**UNITED STATES  
NUCLEAR REGULATORY COMMISSION**  
REGION II  
245 PEACHTREE CENTER AVENUE NE, SUITE 1200  
ATLANTA, GEORGIA 30303-1257

**SUBJECT: WATTS BAR NUCLEAR PLANT UNIT 2 CONSTRUCTION - NRC INTEGRATED  
INSPECTION REPORT 05000391/2010604**

Facility: Watts Bar Nuclear Plant, Unit 2

**FIGURE 1**

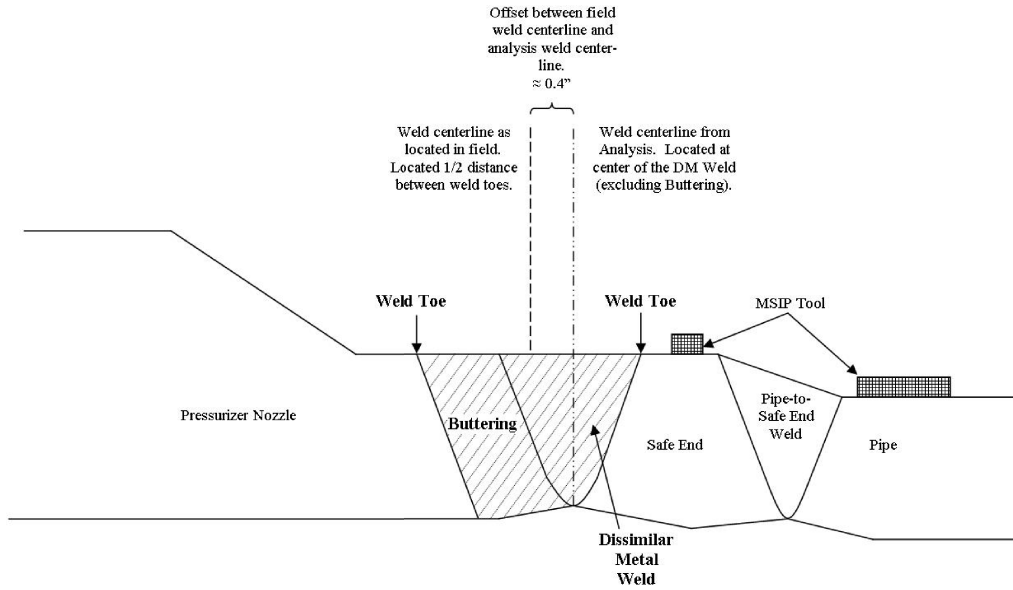
Correct placement of the clamp in the field requires that the same weld centerline used in the stress analysis calculation be marked on the exterior of the weld. Procedure PI-901153-01, "Watts Bar Unit 2 Mechanical Stress Improvement Process (MSIP) Applied to Pressurizer Nozzle to Safe End Welds," was the controlling procedure for the MSIP process. This procedure required the weld centerline to be located and marked. Per Westinghouse Interface Document (25402-011-V1A-MG00-01838-002), paragraph 5.5.3, TVA was required, in part, to "identify and mark the centerline of each dissimilar metal weld (excluding the buttering region)." Location and marking of the weld centerline in the field was performed by TVA personnel using TVA procedure N-GP-8, "Weld Reference System." N-GP-8 is a generic procedure used to establish a weld reference system for welds and areas receiving surface or volumetric examinations, and was not created specifically for the MSIP process. N-GP-8 directed TVA personnel to determine the weld centerline by locating the weld toes (performed with ET examination) at the carbon steel nozzle-to-butter interface and at the DM weld to safe end interface. The weld centerline was then marked at the midpoint between the two weld toes; however, this centerline marking did not correspond to the same centerline established in the stress analysis calculation because it did not account for the thickness of buttering, or any differences in the weld joint bevels between the safe end and the carbon steel nozzle (see Figure 1 of the attachment for an illustration of the surge line nozzle). A note in procedure PI-901153-01 required PCI QC personnel to verify dimensional measurements required as part of the procedure; however the procedure did not identify a technique (for example, direct measurement from a readily identifiable marking on the weld) or criteria to verify the location of the centerline weld, nor was a tolerance for the weld centerline location provided.

On July 22, 2010, the inspectors observed the process of identifying the weld centerline for the pressurizer surge line nozzle DM weld (2-WP-10- SE) using the same procedures described above. However, in this instance NuVision Engineering (contractor) personnel performed the process in conjunction with TVA personnel. Weld toe markings had previously been applied at the safe end weld toe (see Weld Toe B on Figure 1), but the carbon steel nozzle weld toe had not been marked (see Weld Toe A on Figure 1). The inspectors observed TVA personnel apply a low-stress "V" stamp to the carbon steel nozzle weld toe. This location was easily identifiable with the naked eye and, therefore, ET examination was not required. The inspectors then questioned NuVision Engineering personnel on the method to be used to locate the weld centerline and observed the identification of the weld centerline using a process of measuring the distance between the previously located toes of the weld and marking one half the distance between them. This process was consistent with procedure N-GP-8. The centerline mark was confirmed as correct by PCI QC personnel. However, the joint configuration of the surge line nozzle included a layer of weld butter on the carbon steel nozzle side (see Battering on Figure 1), which resulted in an offset between the field marked centerline and the centerline required by the stress analysis (4387-4-001-01, NuVision Engineering, "Analytical Verification of MSIP for Pressurizer Surge Nozzle to Safe End Weld Watts Bar Units 1&2," Revision 1) that was approximately 0.40", and outside the allowable tolerance of  $\pm 0.25$ " provided by the stress analysis calculation. The licensee did not apply MSIP to the pressurizer surge line, and began development of a detailed procedure specifically created to mark the correct weld centerline for the pressurizer surge line nozzle.

The inspectors determined that the licensee's incorrect marking of weld centerlines for the six pressurizer nozzles resulted from the licensee's failure to meet 10 CFR Part 50 Appendix B, Criterion IX, "Control of Special Processes." Specifically, the licensee did not provide a procedure with adequate guidance on how to establish the appropriate weld centerline, and QC checks were not documented with specific criteria or tolerances. The inspectors determined this finding was more than minor in accordance with Inspection Manual Chapter 2517, because it represented an uncontrolled work practice that could impact the quality of safety-related SSCs. This finding has a cross-cutting aspect in the area of Human Performance, H.2(c), because the licensee did not ensure complete procedures were available.
